Re: Limited Drainage and Erosion Inspection
Private Asphalt Greenways
Clayton, NC

SUMMARY OF FINDINGS

Photo No.
27

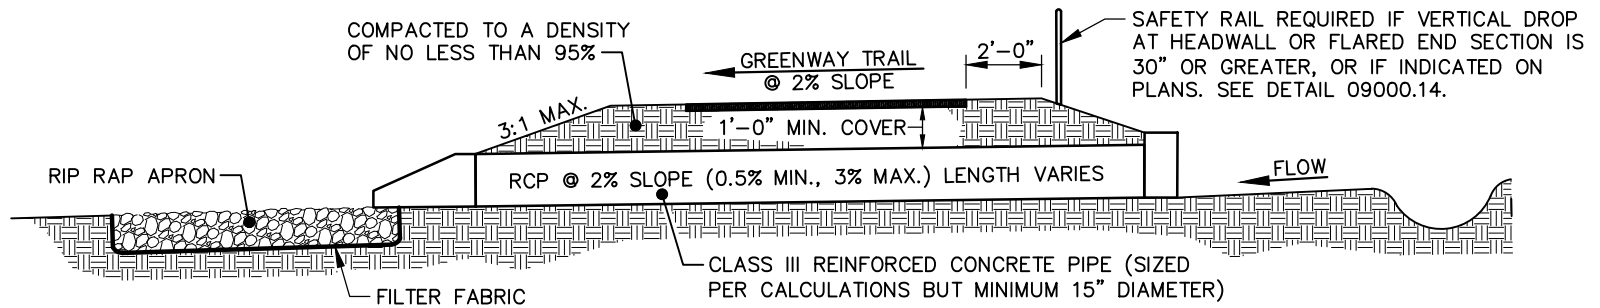
A landscape swale is located between the asphalt greenway and the gravel parking lot for the Town's dog park. A portion of the swale has eroded, with the erosion now extending to the greenway and is undermining the stone base.

Area #15: Area of erosion

We recommend filling the swale to a uniform contour. Typically, fill materials are easily erodible. Therefore, care should be taken to properly compact the backfill to approximately 85% standard proctor density. The area should then be sodded with a warm season grass to prevent erosion during any rain event. The sod may need to be stapled to prevent movement, and watered to ensure establishment.

If the sod does not become established, or erosion continues, the area will likely require armoring with rip rap over a non-woven filter fabric. The rip rap should extend to the edge of the asphalt greenway. The rip rap will need to be keyed into the existing grade, such that the top of the rip rap will be flush with the grass surface (not sit above the rip rap). While this will cause ponding of water in the rip rap, this is standard practice in order to mitigate erosion in the swale.

Photo No.
28

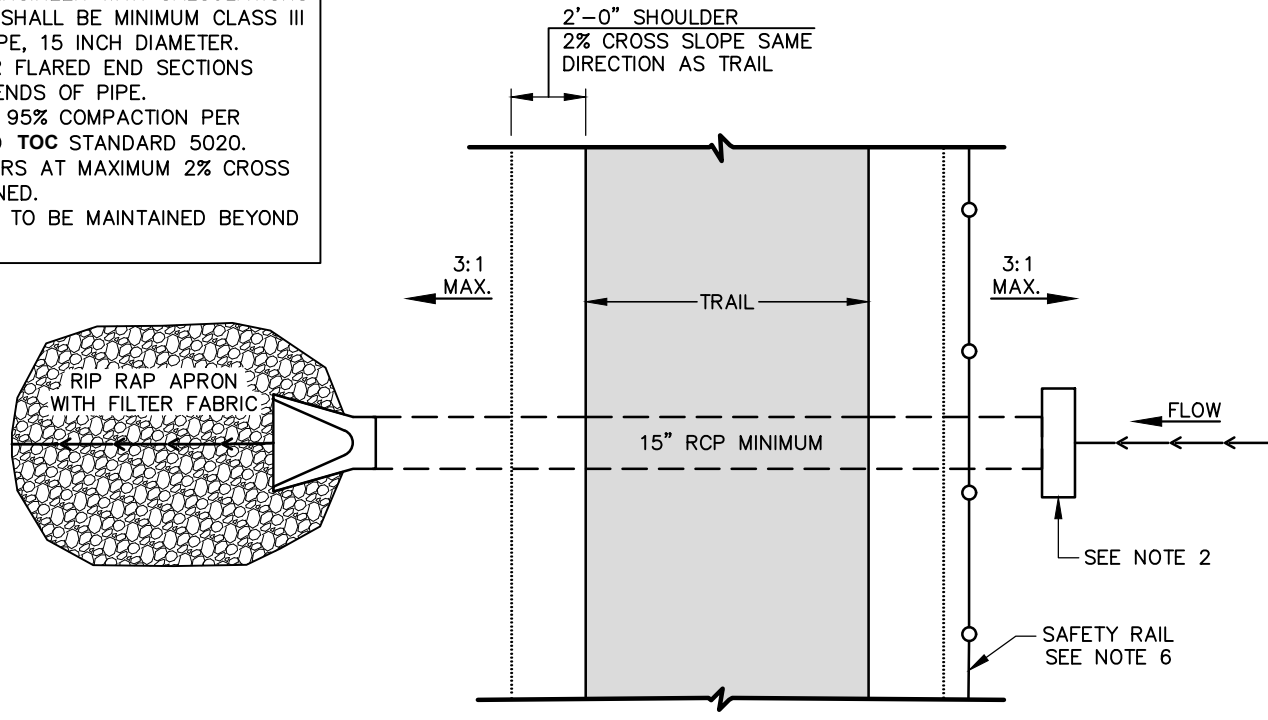
Area #15: erosion is beginning to undermine greenway
